# Wisconsin Department of Transportation

**Proposal #01: 1010-10-82, WISC 2024324**  
**Madison – Portage**  
**Wisconsin River Bridges**  
**IH 39**  
**Columbia County**

This is Addendum No. 03, which provides for the following:

**ADDENDUM NO. 03**

NO. DATE REVISION BY  
3 4/3/24 NOTES STATE OF WISCONSIN DEPARTMENT OF TRANSPORTATION STRUCTURES DESIGN SECTION  
STRUCTURE B-11-184  
DESIGNED BY JLR  
CHECKED BY JLR  
SHEET 62  
834

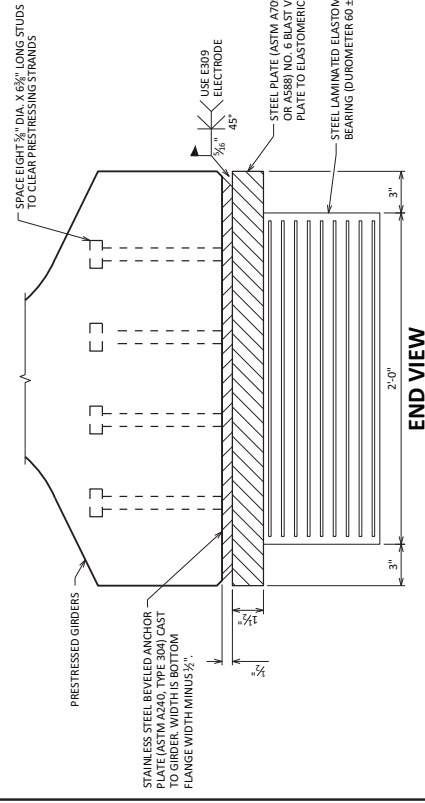
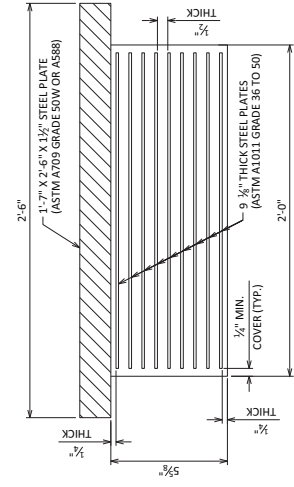
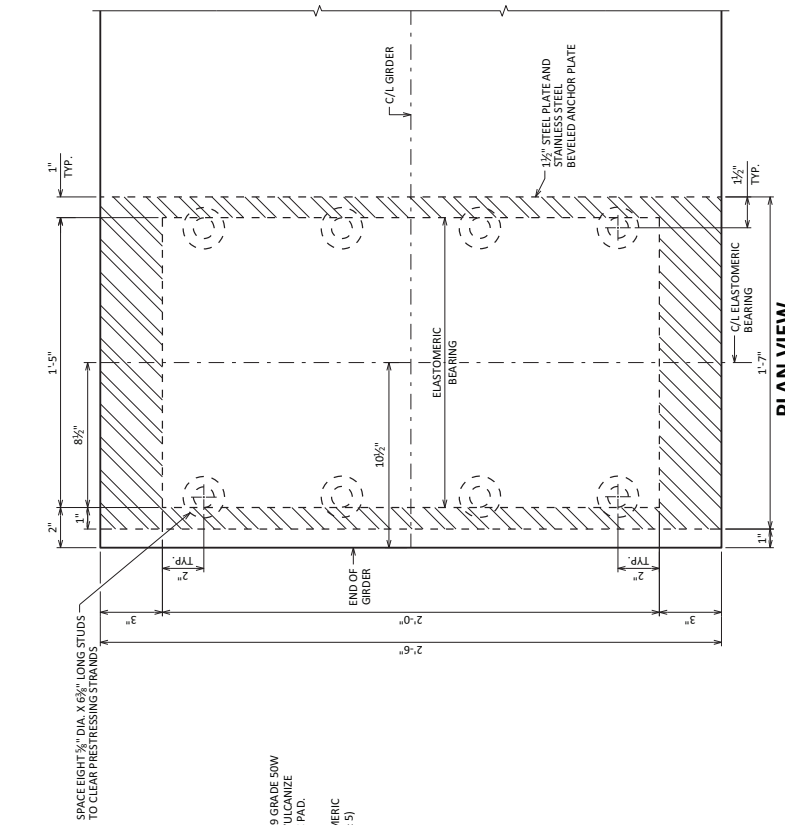
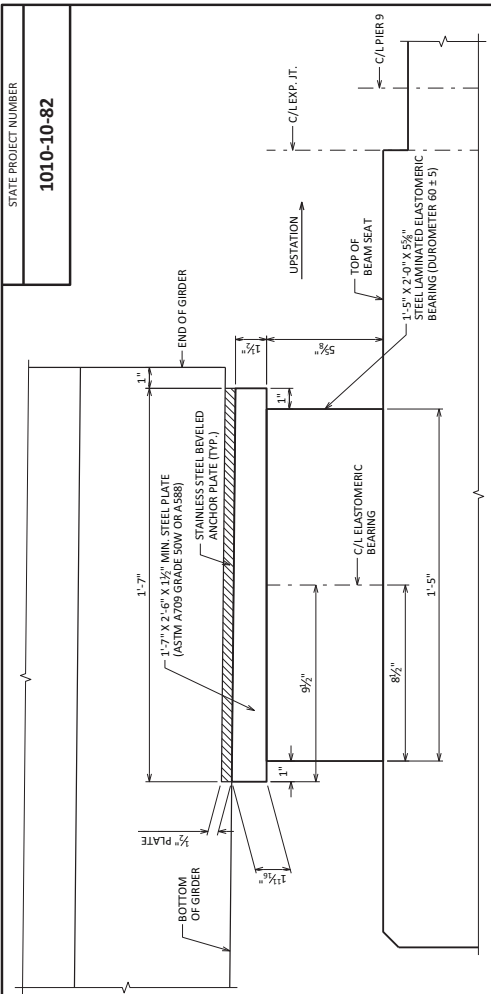
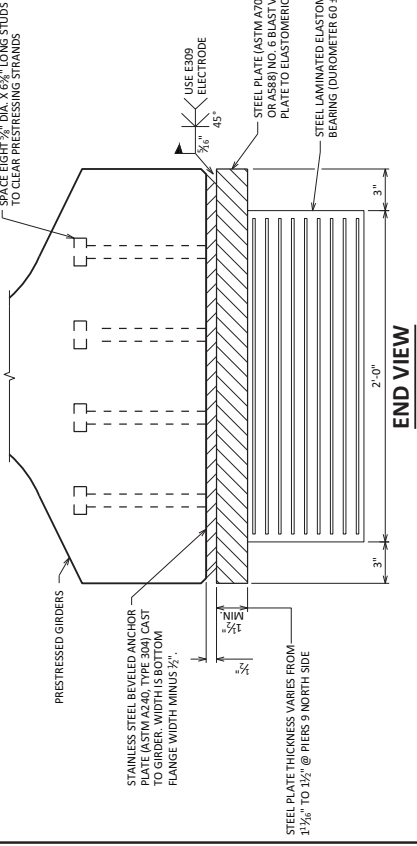
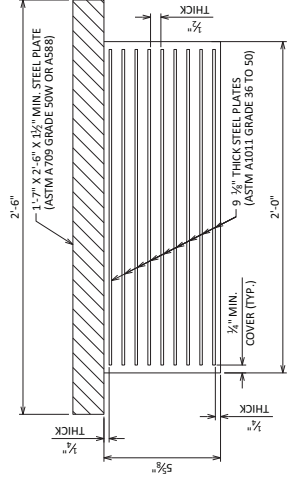
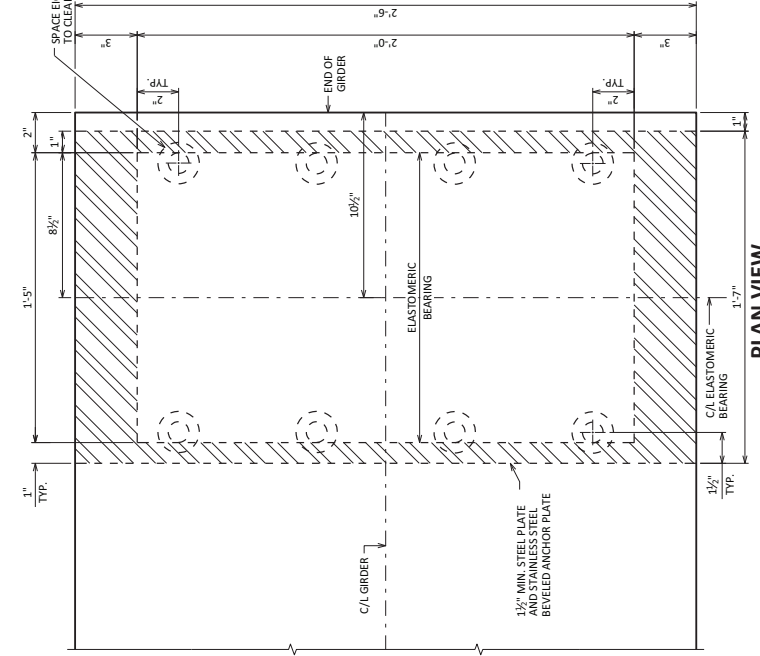
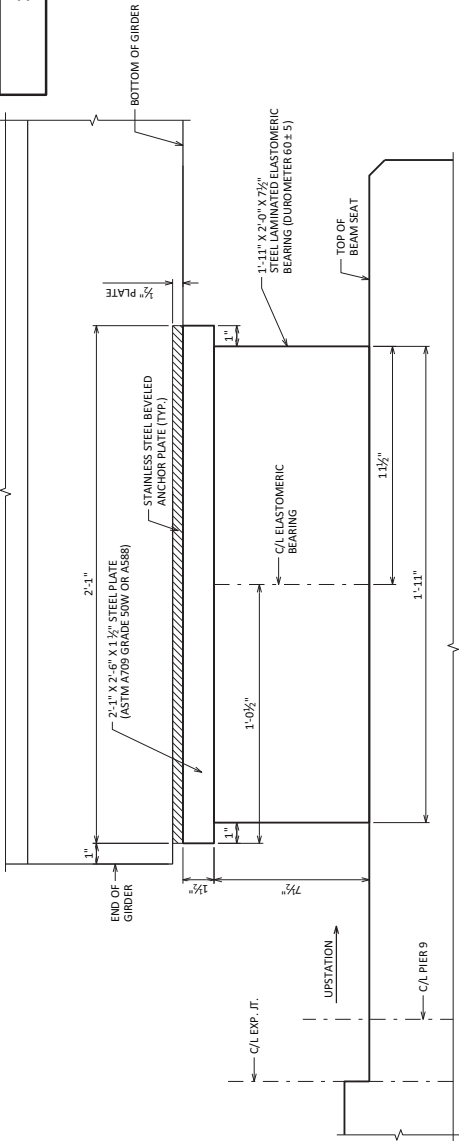
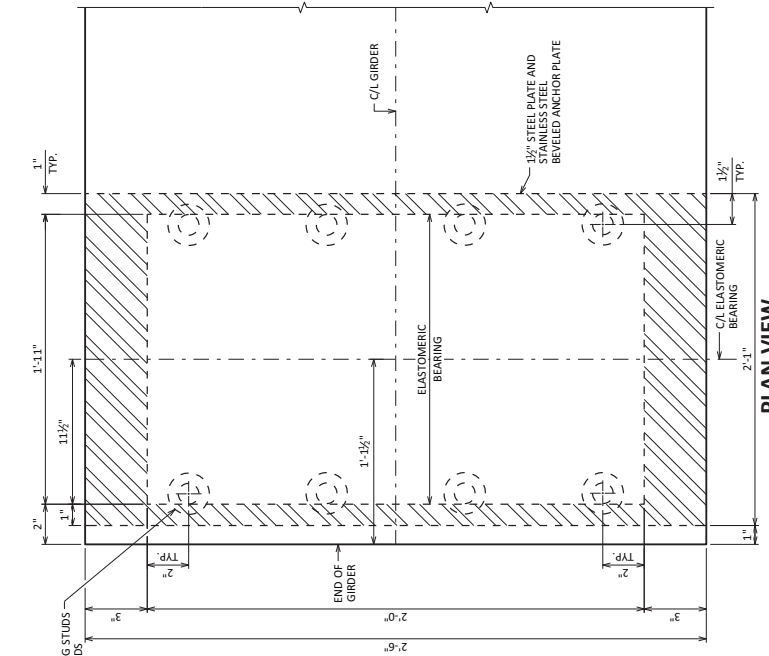
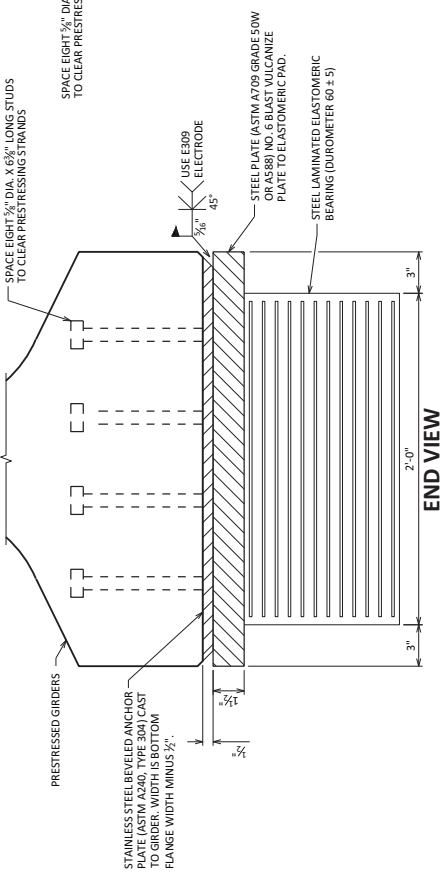
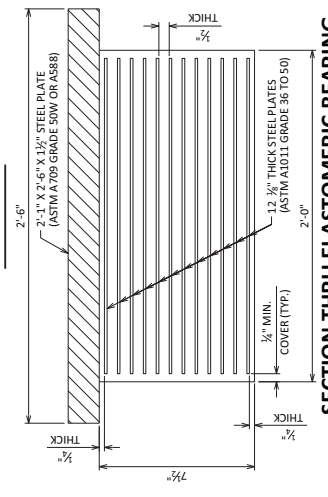
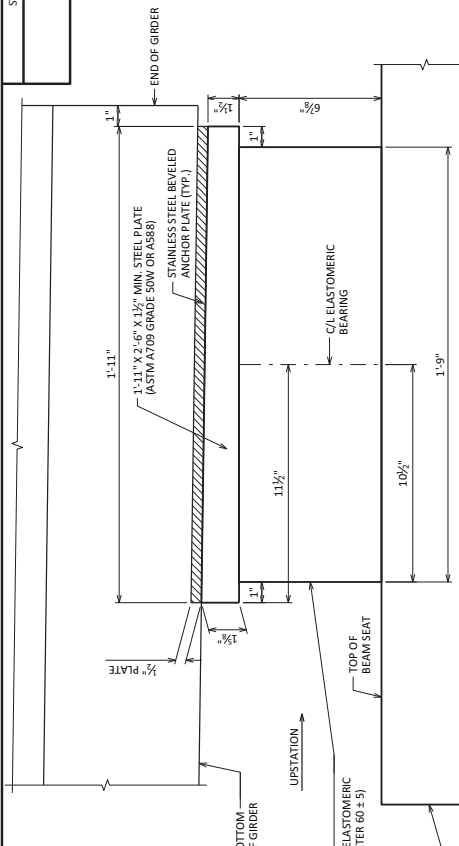
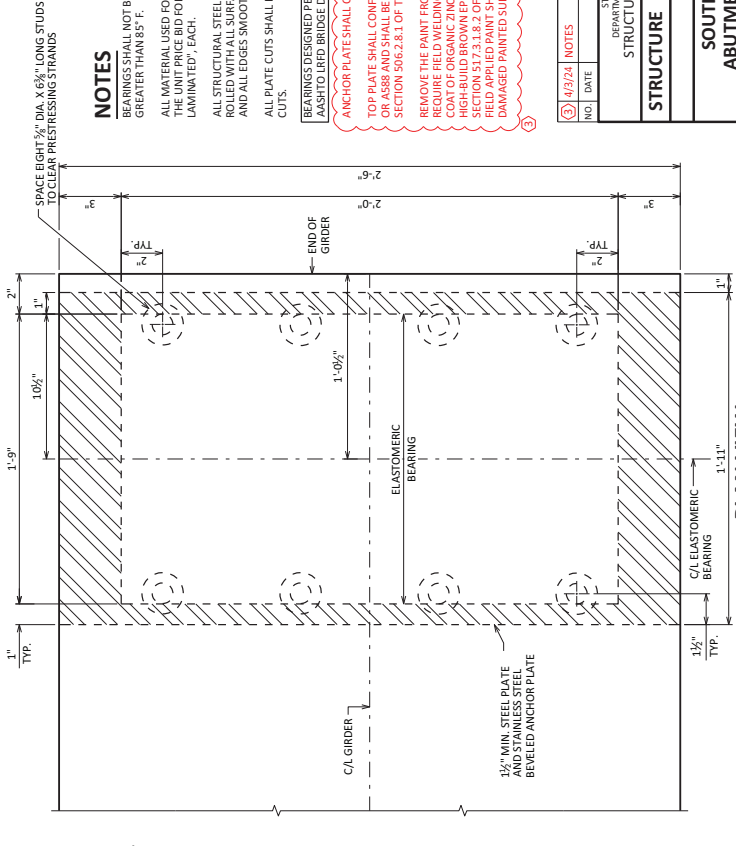
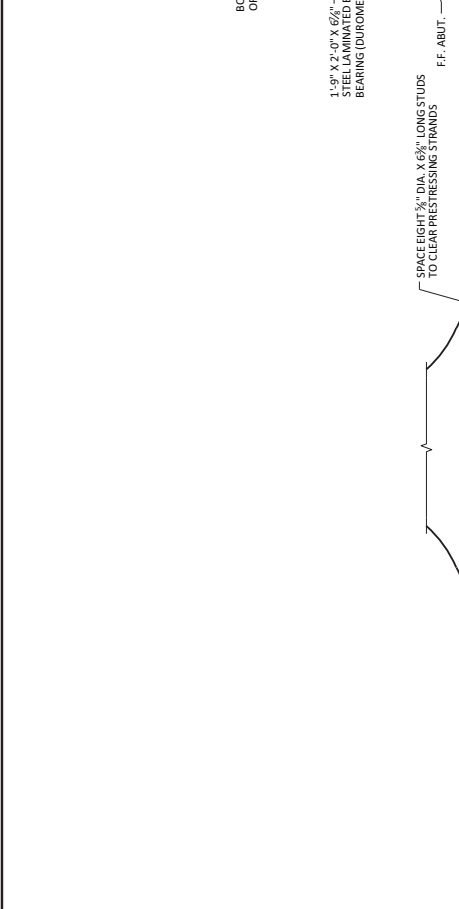
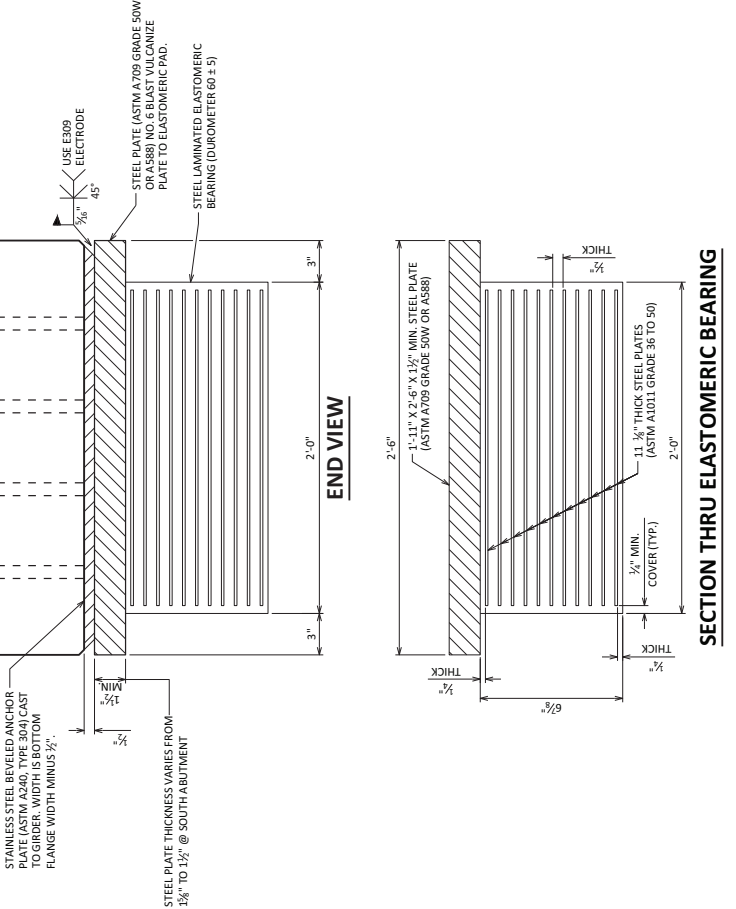
834 to 838	B-11-184 Structure Plan – Additional notes included.
881	B-11-185 Structure Plan – Removed a note referring to a beveled anchor plate that is not required.
920, 922 & 926	R-11-048 Structure Plan – Minor revisions to quantities, a soldier pile detail, and soldier pile data.

STATE OF WISCONSIN  
DEPARTMENT OF TRANSPORTATION  
STRUCTURES DESIGN SECTION  
**STRUCTURE B-11-185**  
DESIGNED BY JLR  
CHECKED BY JLR  
SHEET 10  
**881**

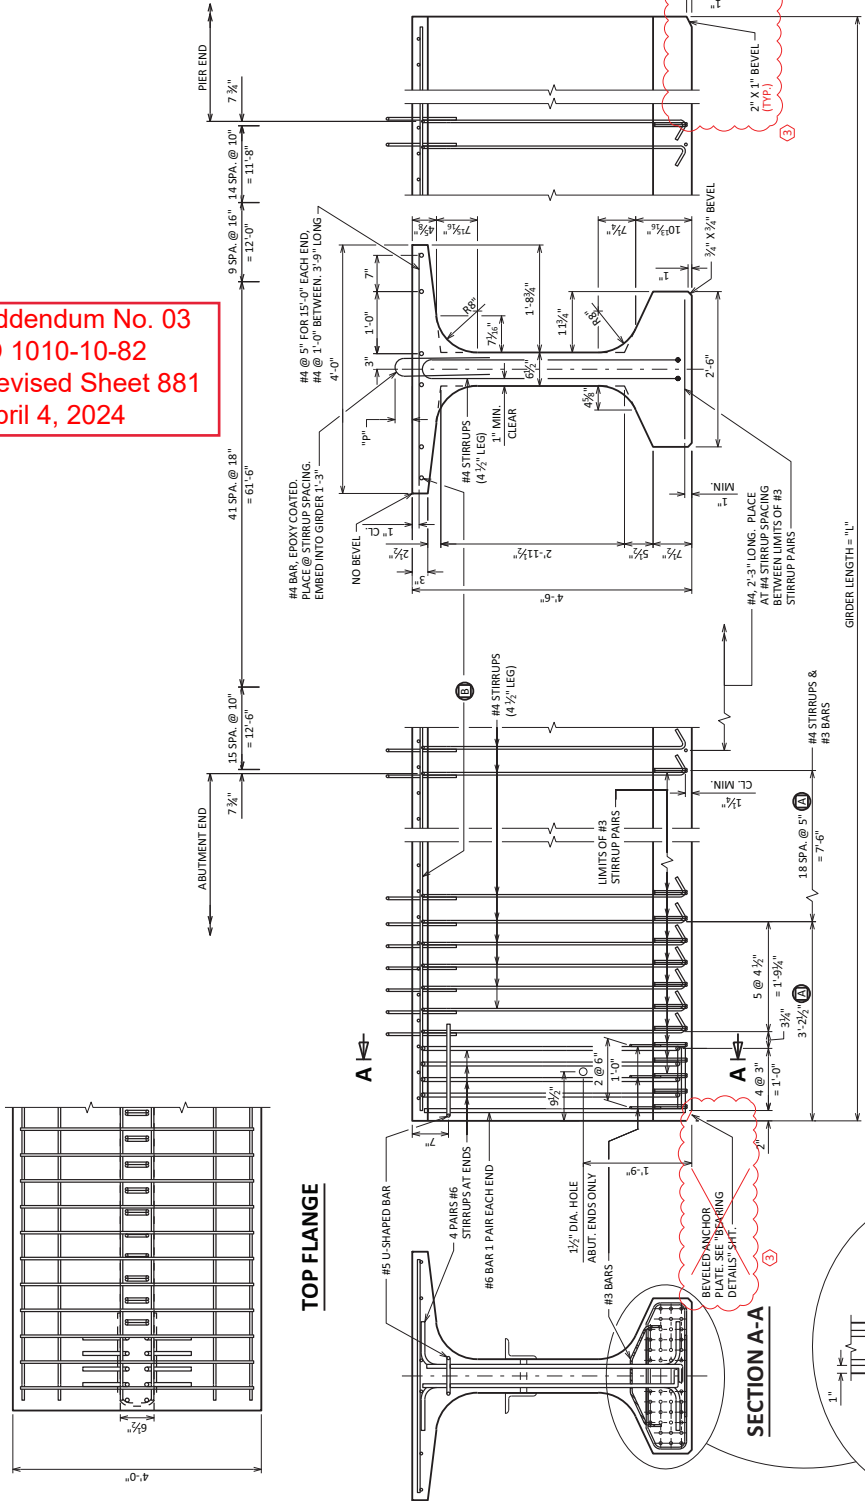
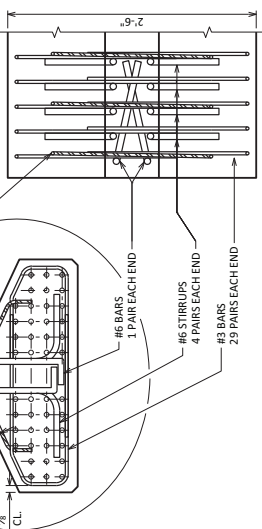
REVISION NO. DATE BY  
③ 4/1/24 REMOVED BEVELED ANCHOR PLATE JLR
